August 30, 2019

Project No. 19080-01

Subject: *Preliminary Geotechnical Recommendations Regarding the Updated Mass Grading Plan and Haul Route Study, Phase 2b, Tract No. 36294, Bedford, Corona, California*

Preliminary Geotechnical Map
Updated Phase 2b Mass Grade Plan and Haul Route Remediation Study #1

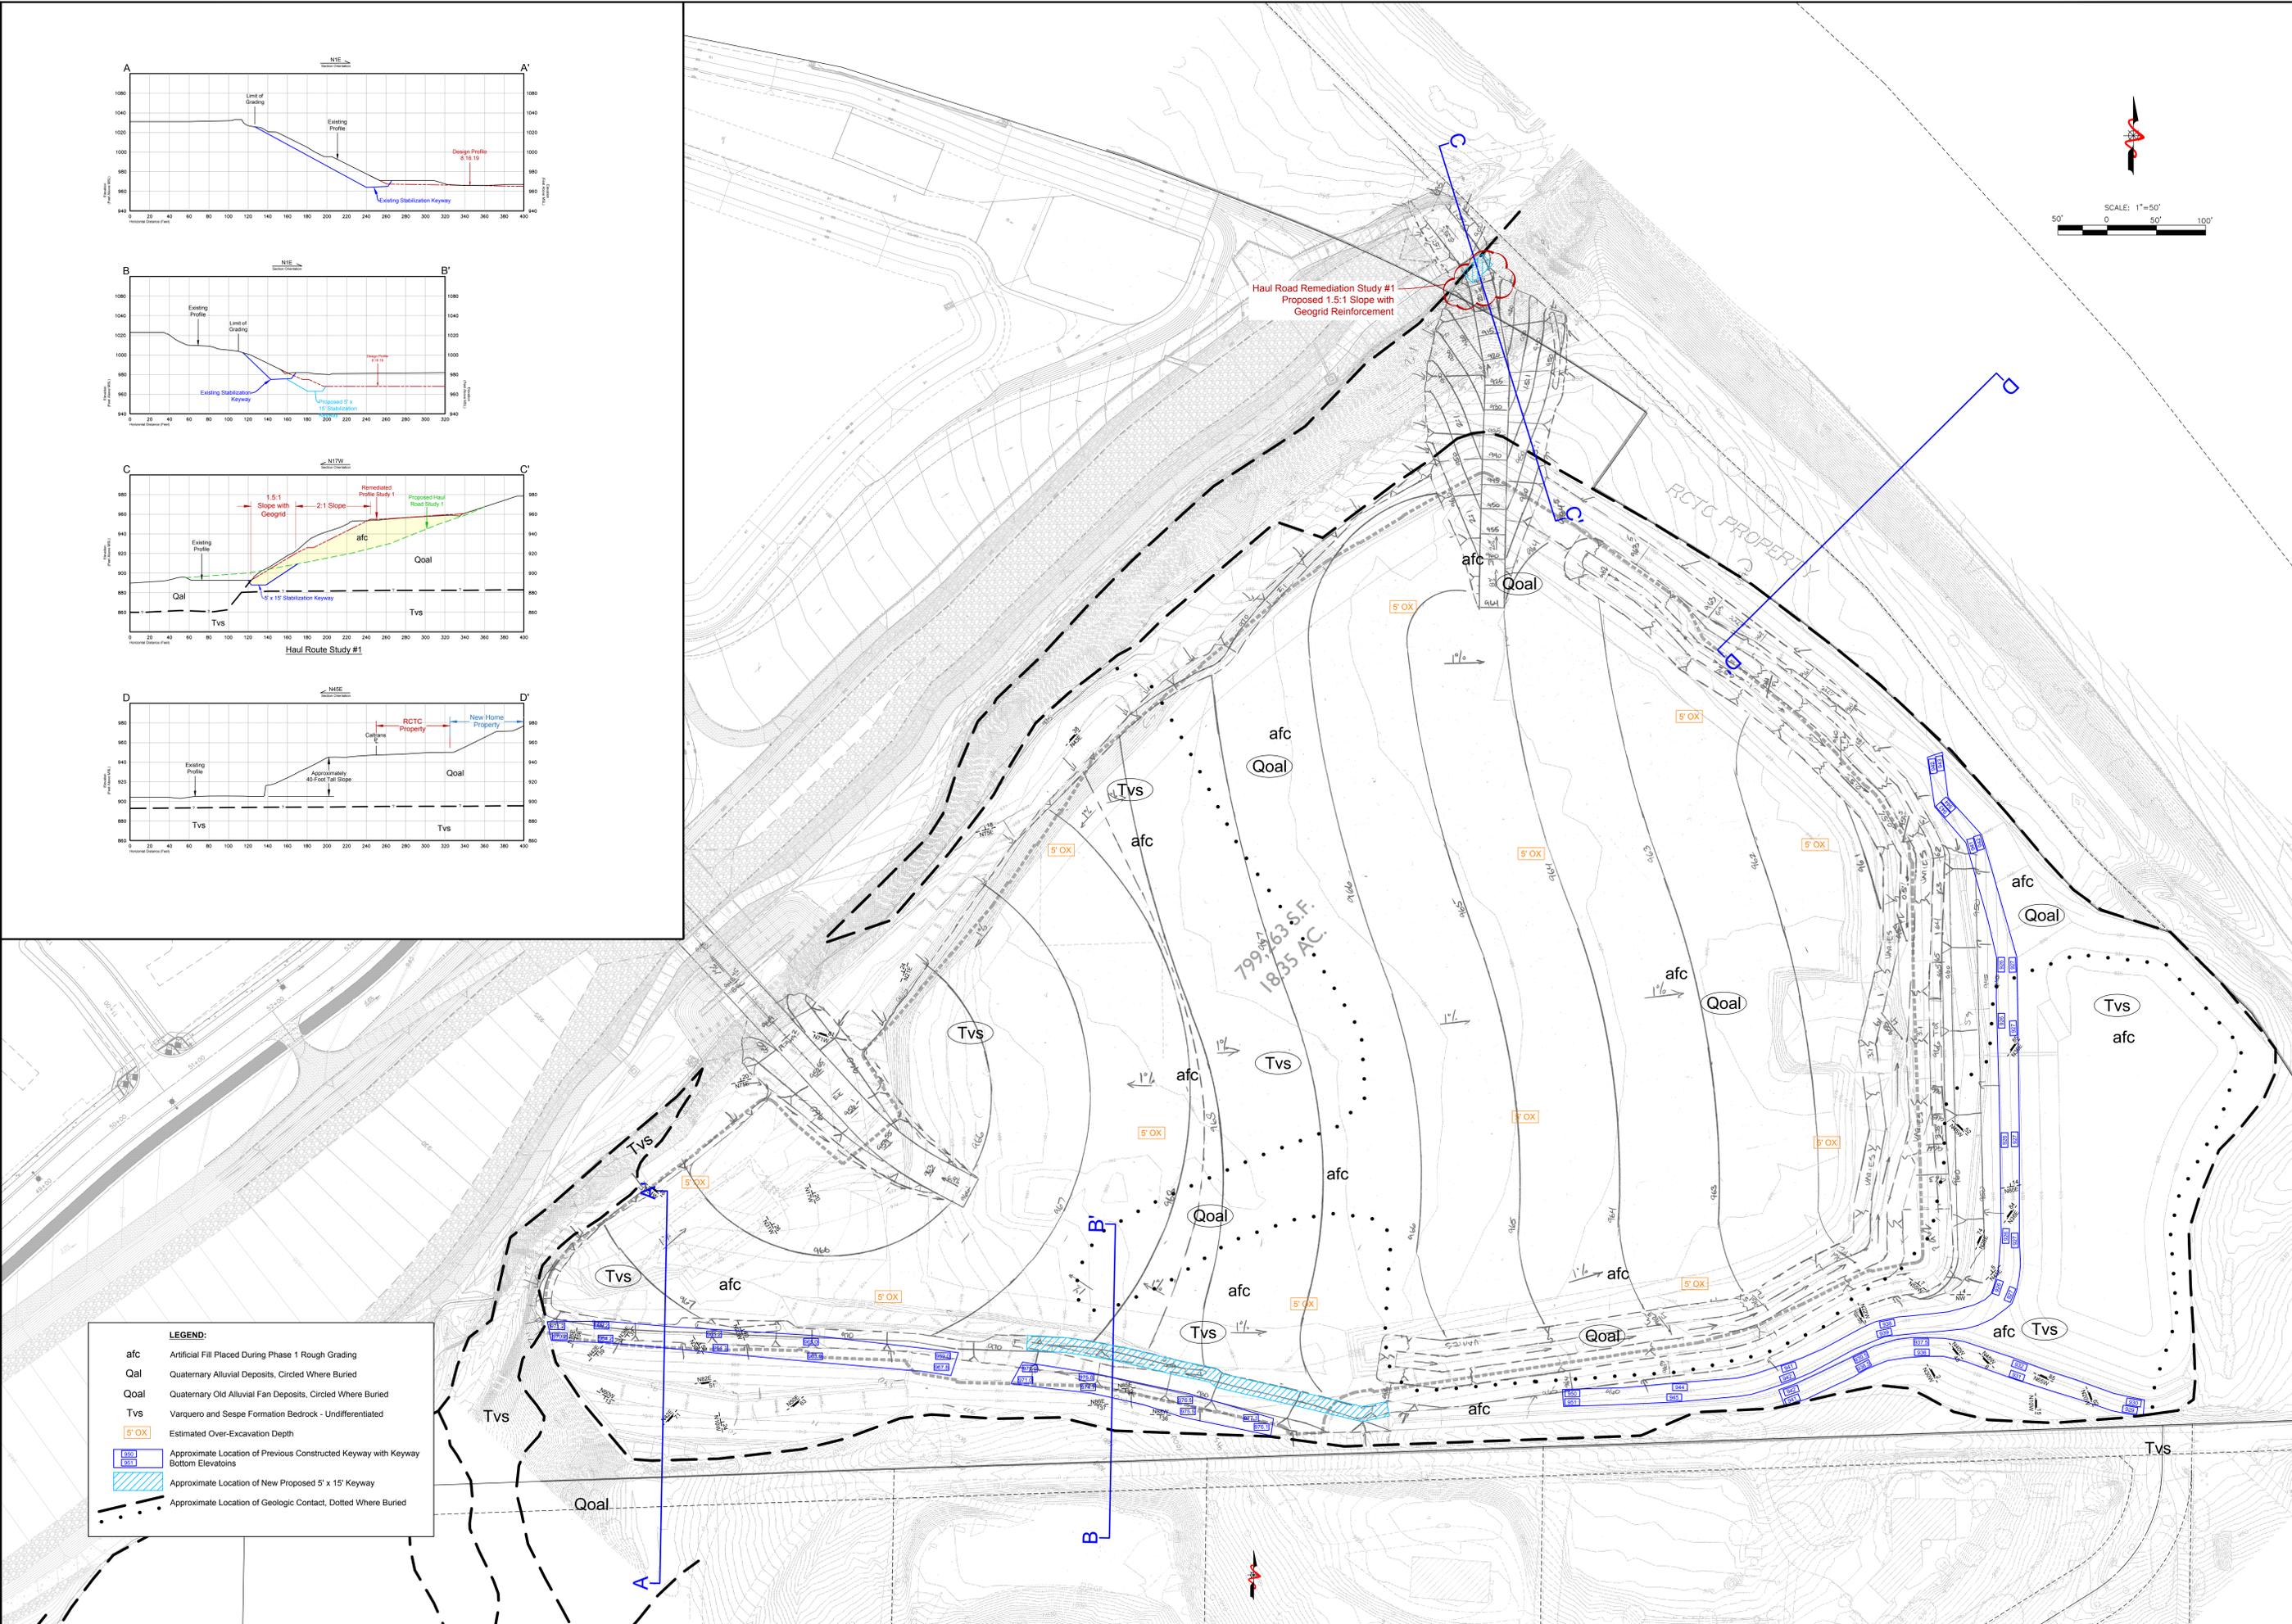
2 percent or 1-foot, whichever is greater. Stabilization fill backcuts should be excavated so that at least a minimum 15-foot-wide fill width is maintained for the entire height of the stability fill slope. Backcuts should be excavated at a maximum 1.5:1 (horizontal to vertical) inclination or flatter. Properly outlet backdrains should be constructed along stabilization fill backcuts. Approximate locations of stabilization fill keyways are depicted on the Preliminary Geotechnical Map (Sheet 1).

- The proposed slope associated with the haul route remediation is anticipated to be superficially stable at inclinations of 2:1 (horizontal to vertical) or flatter. Sections of fill slopes depicted at inclinations of 1.5:1 (horizontal to vertical) will require geogrid reinforcement. See Section C-C' (Sheet 1).

- We recommend that proposed 1.5:1 (horizontal to vertical) fill slopes be constructed with geogrid reinforcement. Beginning approximately at the toe of slope, 8-foot lengths of geogrid reinforcement with a minimum Long-Term Design Strength (LTDS) of 500 lbs/ft (Miragrid 2XT or approved equivalent) should be placed horizontally across the entire width of the 1.5:1 (horizontal to vertical) fill slope. The geogrid reinforcement should be placed every 2 feet vertically and be "day-lighted" to the slope face. Manufacturer's recommendations regarding installation of geogrid should be implemented during construction.

- Based on our review of Section D-D' (Sheet 1), a geotechnical setback from the Caltrans property limit is not necessary. However, setbacks in accordance with the California Building Code (CBC) should be applied by the project civil engineer, where applicable.
